RESOLUTION NO. 2019 - 191

**A RESOLUTION BY THE BOARD OF COUNTY COMMISSIONERS OF ST. JOHNS COUNTY, FLORIDA, AUTHORIZING THE COUNTY ADMINISTRATOR, OR DESIGNEE, TO AWARD BID NO. 19-53 AND TO EXECUTE AN AGREEMENT FOR HOLIDAY ISLE LIFT STATION IMPROVEMENTS.**

- 2.01 The Project, of which the Work under the Contract Documents is a part, is generally described as follows:
- A. Bid No. 19-53: Holiday Isle Lift Station Improvements

HOLIDAY ISLE LIFT STATION  
IMPROVEMENTS  
OVERALL SITE PLAN

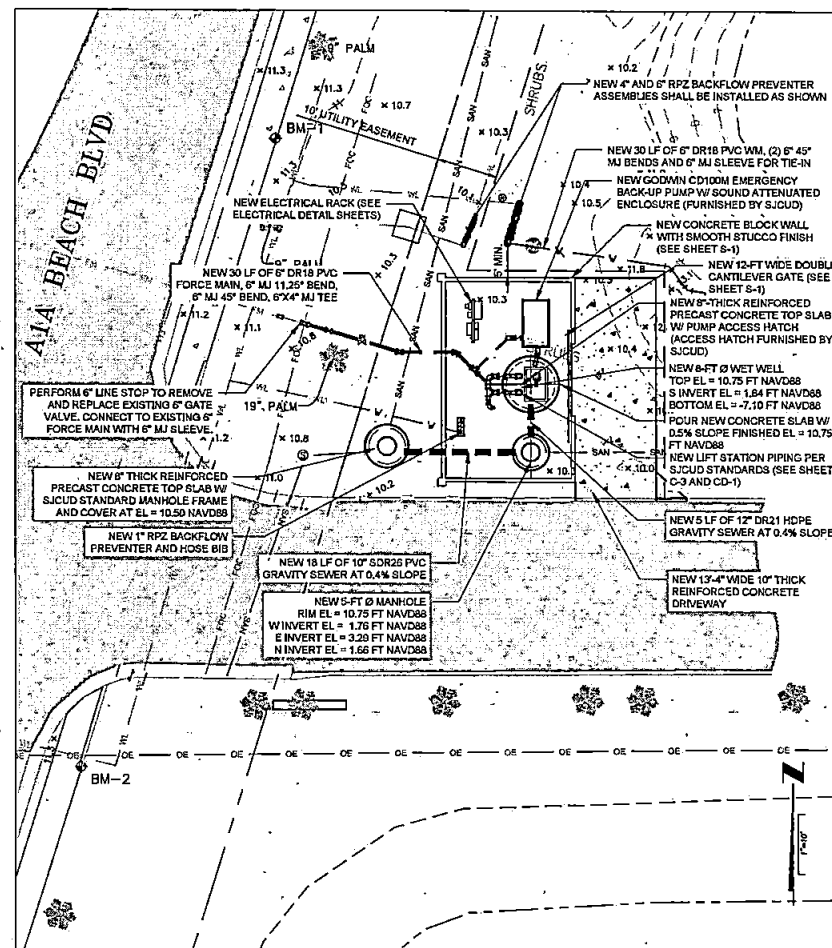
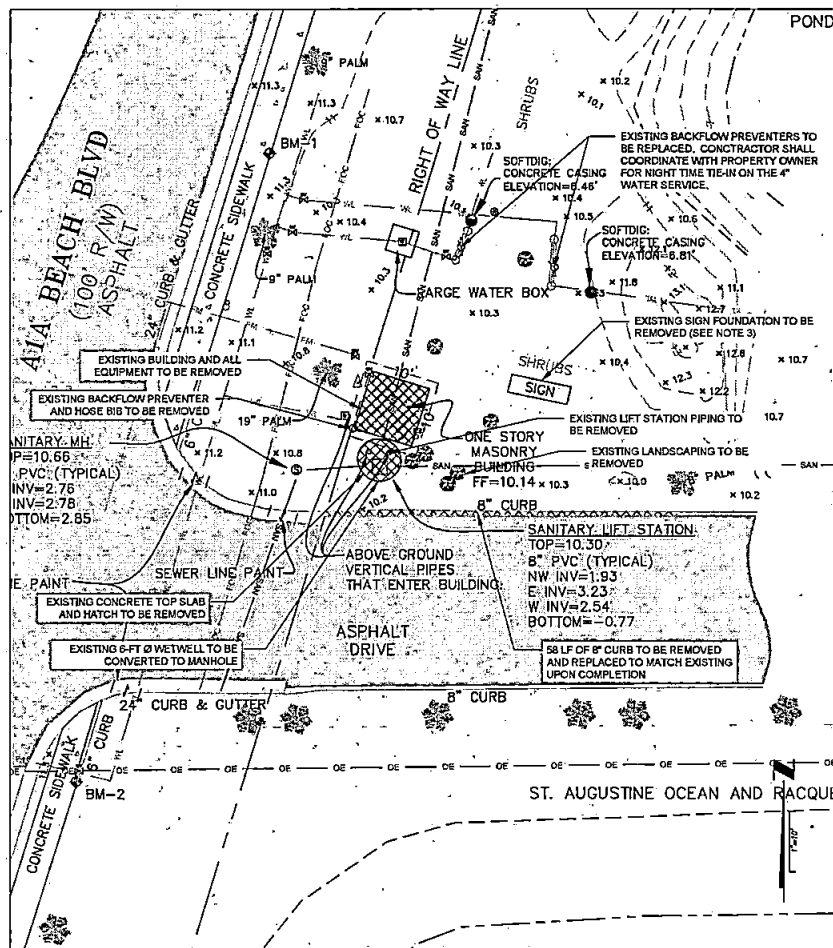
2. **Question:** The Bid Plans specify that the County is furnishing certain equipment on Sheets C-1, C-3 and C-4. Can SJCUD provide information from Xylem on the equipment furnished?

6. **Question:** Does SJCUD have another location for laydown area and storage of excess material from the excavation?

The proposed limits of construction are shown on Sheet C-1. The entrance to the Resort shall remain open at all times. Work with the entrance driveway shall be temporary and notification shall be provided in advance to Resort

1. **Clarification:** The Sequence of Construction is provided on Sheet C-1. The Sequence of Construction is assumed to be the most efficient method of constructing the new lift station and decommissioning the existing lift station to limit bypass pumping. The Contractor shall ultimately determine the construction sequence and the best methods to deliver the project.
